S-TECH JL Lower Install Update

Use of Mopar Cubby Alignment Washers

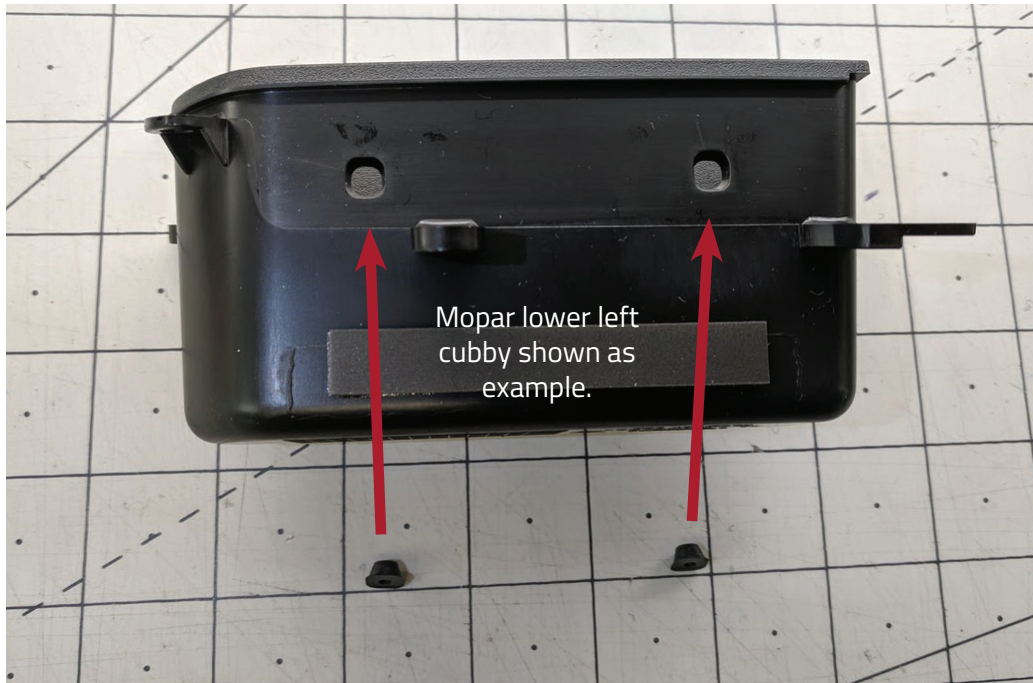
The two small plastic alignment washers (indicated with red arrows) must be used on all Mopar / JL cubbies to align the S-TECH face. All 4 brass grommet screws must also be used for the 6 + 2 and 8.
